Bramford to Twinstead Reinforcement

Document 8.9.3: Applicant's Responses to Second Written Questions

Final Issue A
January 2024

Planning Inspectorate Reference: EN020002

Sheet 1

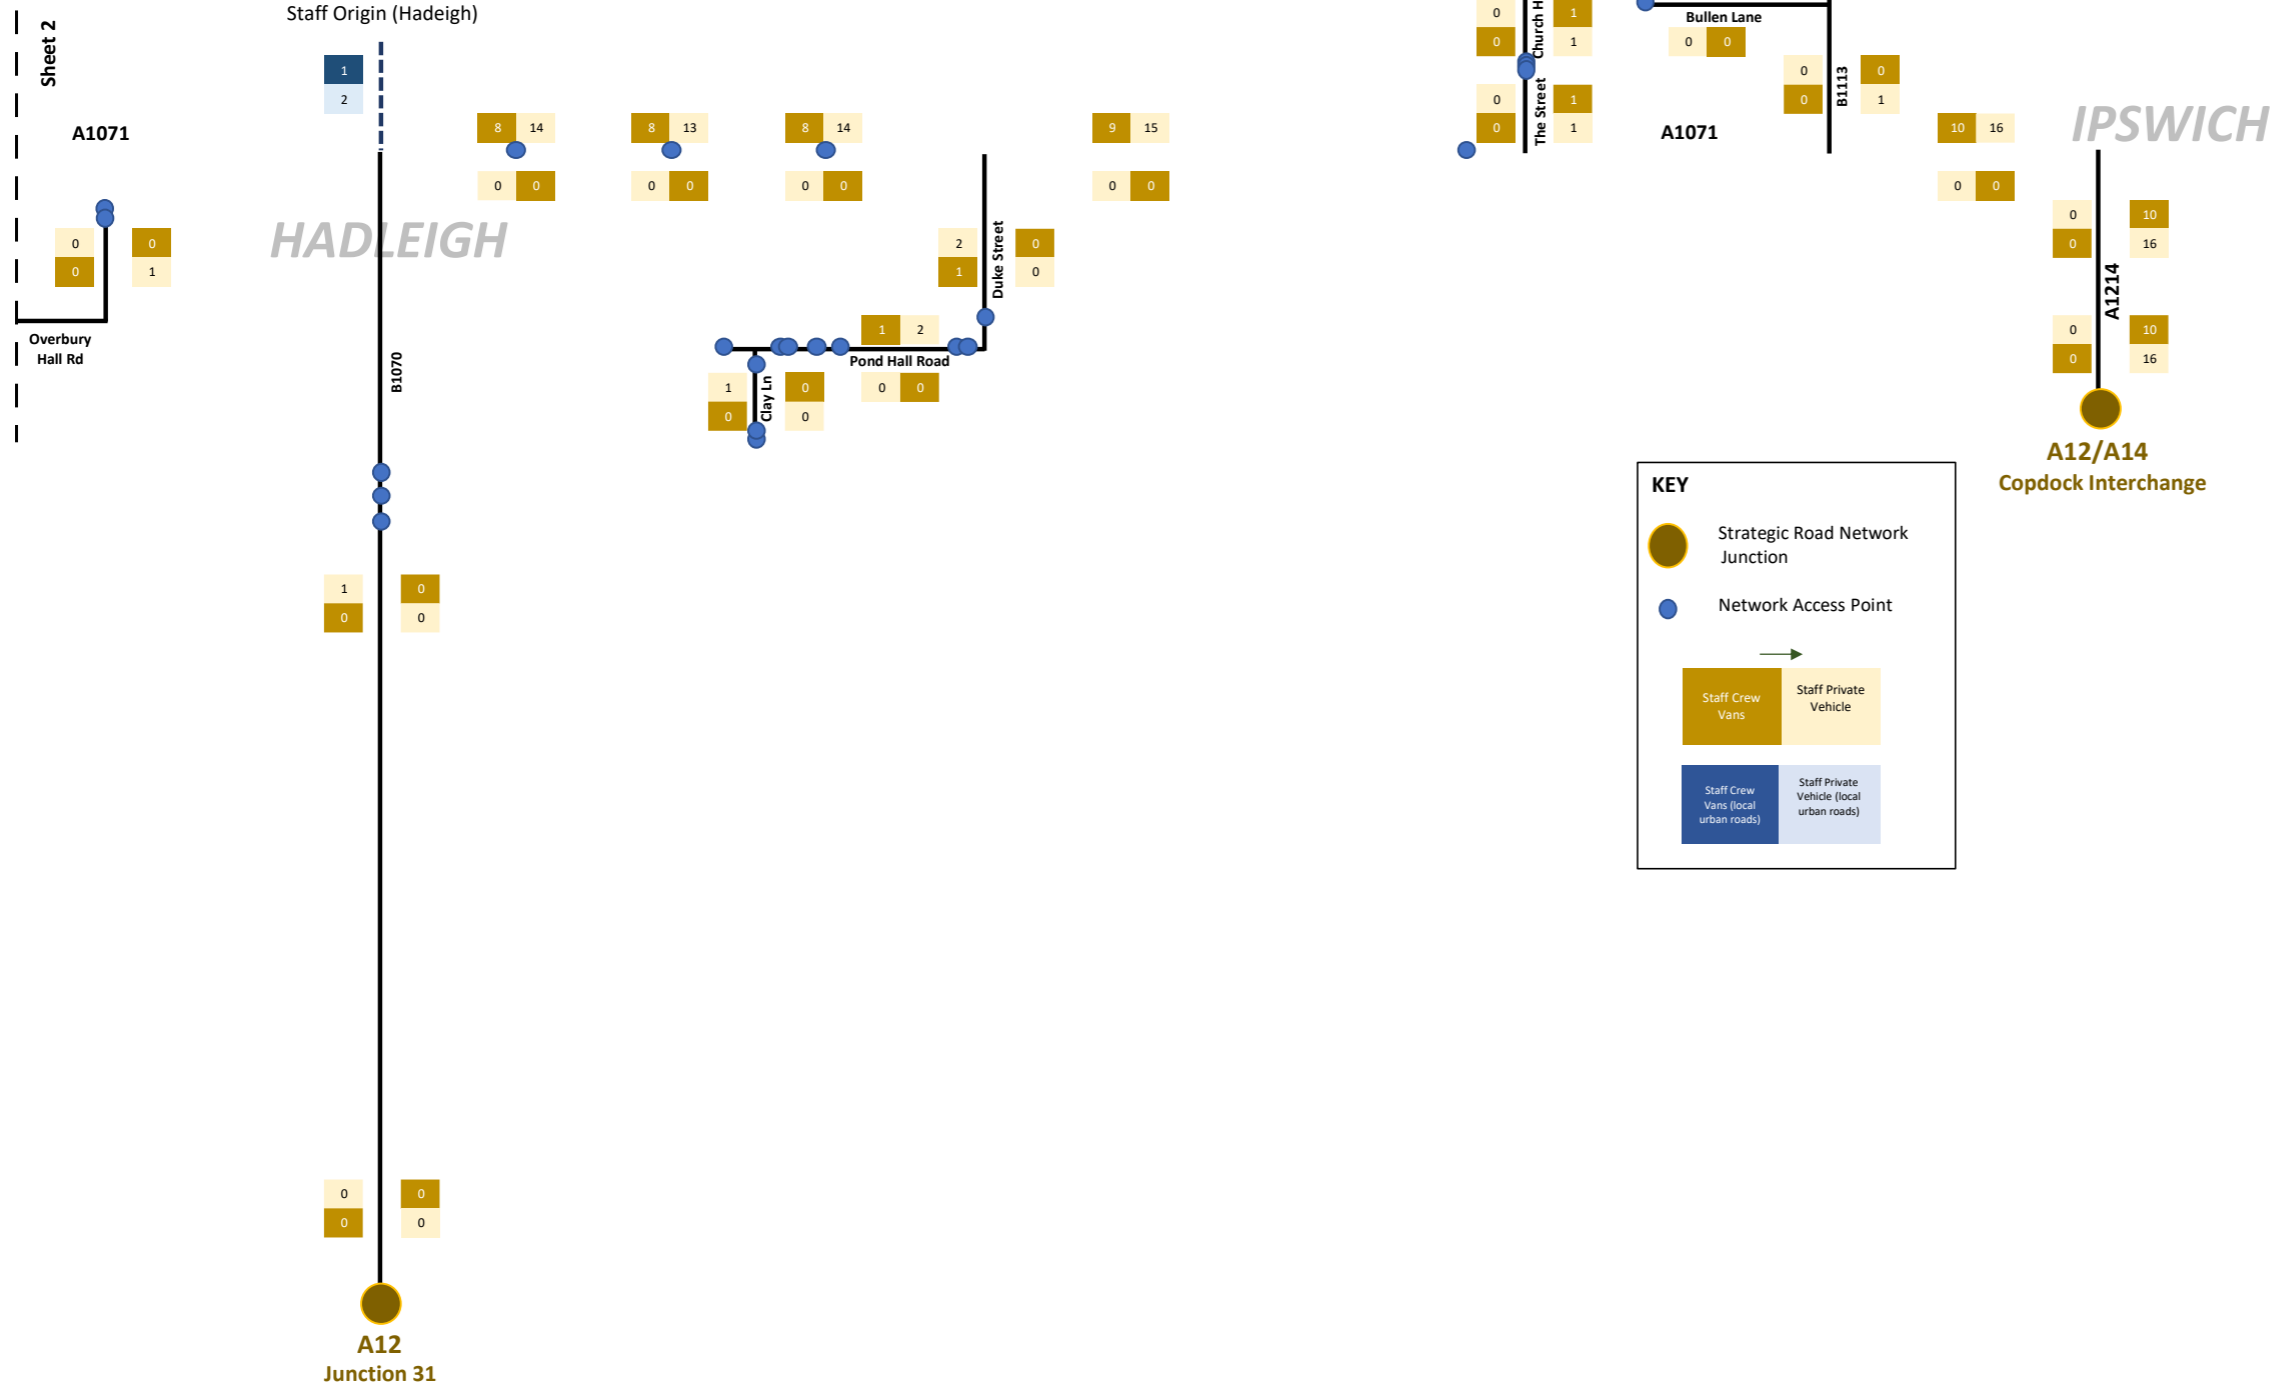
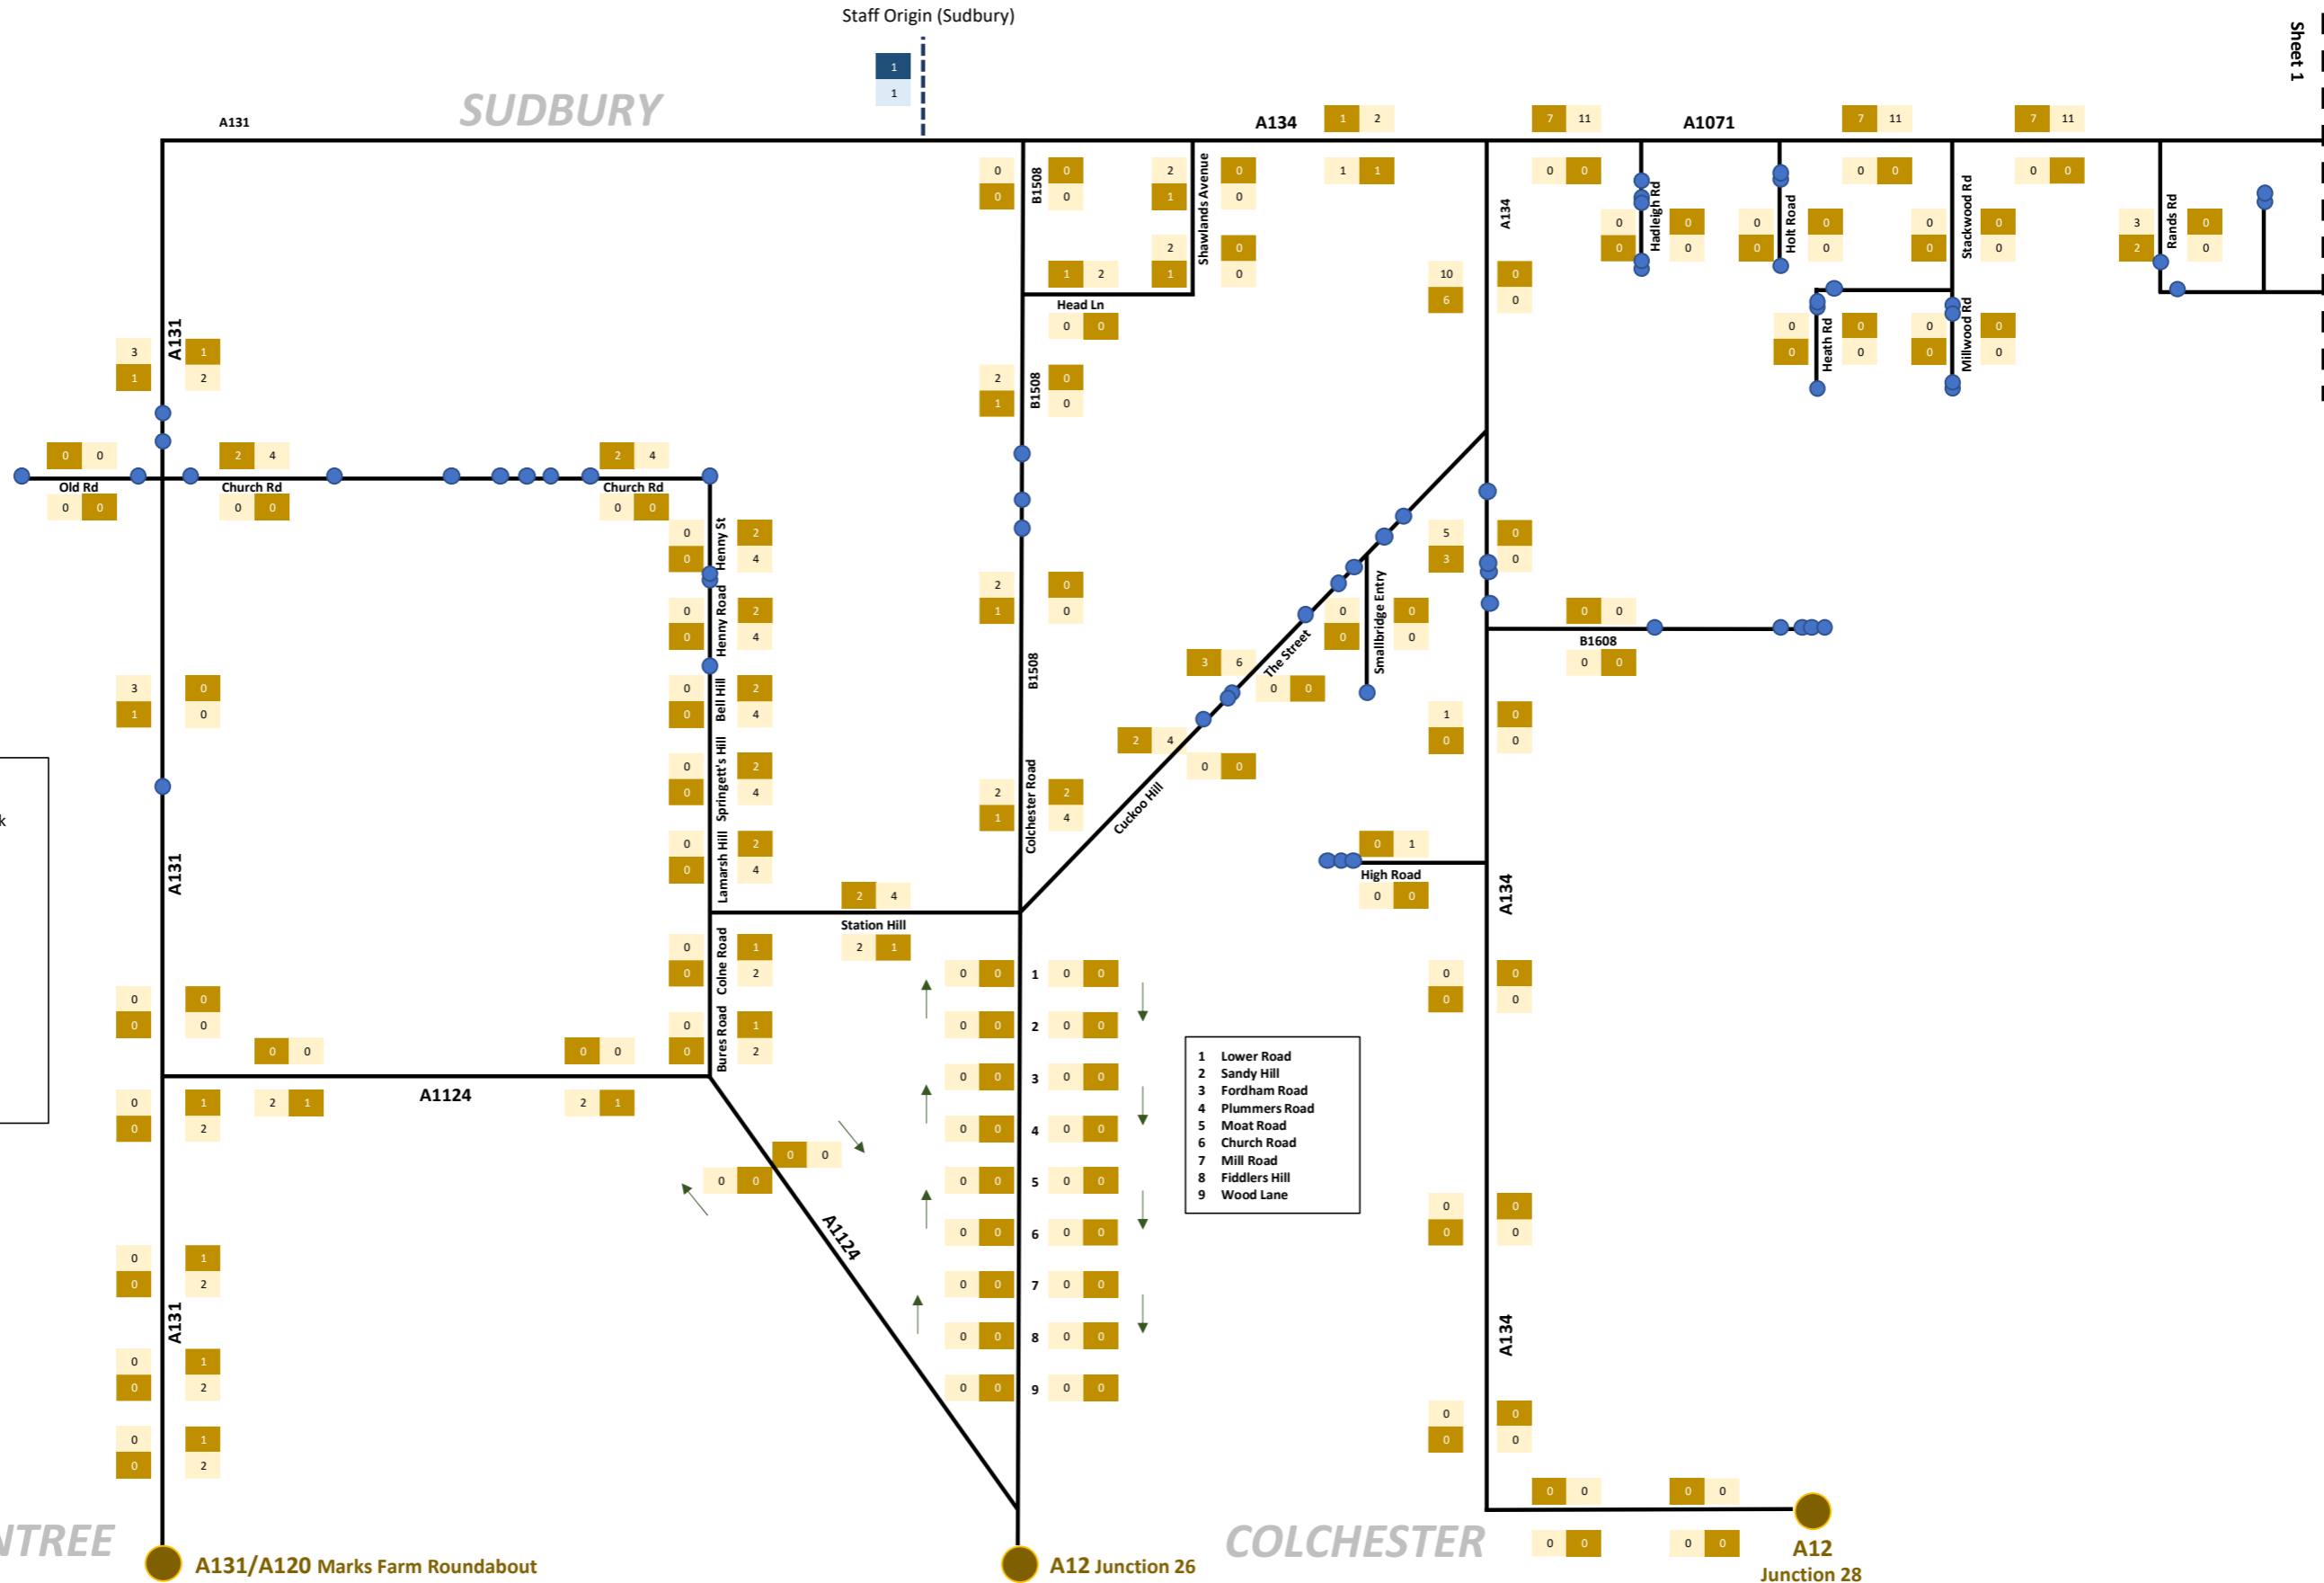
TT2.13.6	<p>The Transport Assessment ([APP-061] paragraph 6.2.12) explains that the peak daily and hourly construction vehicle forecasts are presented in the traffic flow diagrams (Figure 7) as two-way directional construction traffic flows. Can you confirm if these data include the forecast construction staff vehicle movements? If so, can you provide traffic flow diagrams to show the forecast crew minibuss movements, based on the vehicle occupancy factors to derive staff vehicle forecasts (paragraph 6.2.9 of the Transport Assessment), on the local road network in the study area during the</p>	<p>The Applicant can confirm that the data in Figure 7 in the Transport Assessment [APP-061] does include the forecast construction staff vehicle movements within the 'Light Goods Vehicle' category. Construction staff vehicle movements in the morning and evening peak hours (split by cars and crew vans in accordance with the assumptions set out in the Transport Assessment [APP-061]) are provided on the traffic flow diagrams in Appendix A: Construction staff vehicle flow diagram to this response.</p>
